Access Compliance Report

Public Rights-of-Way

Intersection ID: 19936	Main Street: ARCHDALE_DR	Cross Street: CHERRYCREST_LN	Location: NE
ADA ID: AF07E75C4013	Ramp Type: PerpDiag	Initial Pass/Fail: Fail	Overall Compliance: No
			Severity Score: 33.75

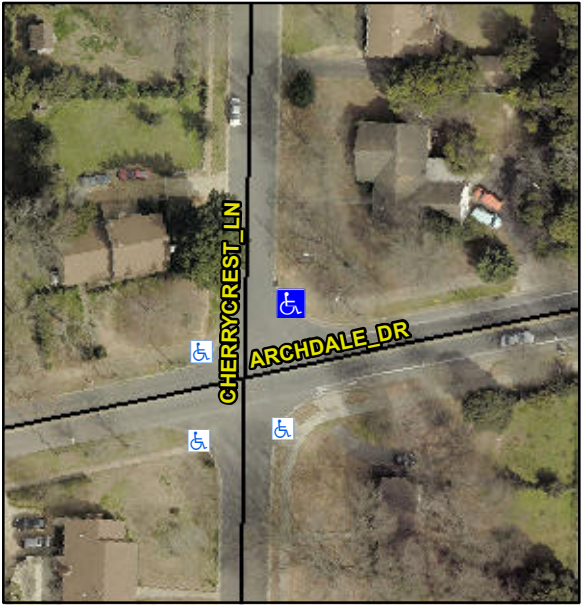
Codes/Mitigation Info/Possible Solution			Field Measurements/Component Compliance		
	Possible Solutions:		Compliance	Description	Data
	Remove & Replace Curb Ramp With Two New Directional Ramps or Equivalent.		No	Ramp Length (in)	70.0
			No	Ramp Width (in)	46.0
			N/A	Flare Type LT	N/A
			N/A	Flare Slope LT (%)	N/A
			N/A	Flare Traversable LT?	N/A
			N/A	Landing Length (in)	N/A
			N/A	Landing Width (in)	N/A
			N/A	Landing Slope (%)	N/A
			N/A	Landing X Slope (%)	N/A
<p>Surveyor Notes:</p> <p>N/A</p> <p>PROW/ADA:</p> <p>Not Found, R304.5.1, R304.2.2, R304.5.3</p>			N/A	Flare Type RT	N/A
			N/A	Flare Slope RT (%)	N/A
			N/A	Flare Traversable RT?	N/A
			N/A	DWS Provided?	N/A
			N/A	DWS Contrast?	N/A
			N/A	DWS Length (in)	N/A
			N/A	DWS Full Width?	N/A
			N/A	DWS Offset (in)	N/A
			N/A	Gutter Ponding?	N/A
			N/A	Gutter Lip Ht (in)	N/A
<p>Total Cost:</p> <p>\$ 3200.00</p>			No	Painted X Walk1?	No
				X Walk 1 Direction	To SW

N/A	X Walk 1 Width (in)	N/A
			4.9	X Walk 1 Slope (%)	1.9
			2.0	X Walk 1 X Slope (%)	4.2
			N/A	Ramp inside XWalk1?	N/A
			4.9	Road Slope (%)	N/A
			3.8	Road X Slope (%)	N/A
			N/A	Any Obstructions?	N/A
				Obstruction Type	
			N/A	Storm Grate/Utility Hazard?	N/A
				Storm Grate/Utility Type	
			N/A		N/A
			Yes	Surface Condition? (G/P)	Good
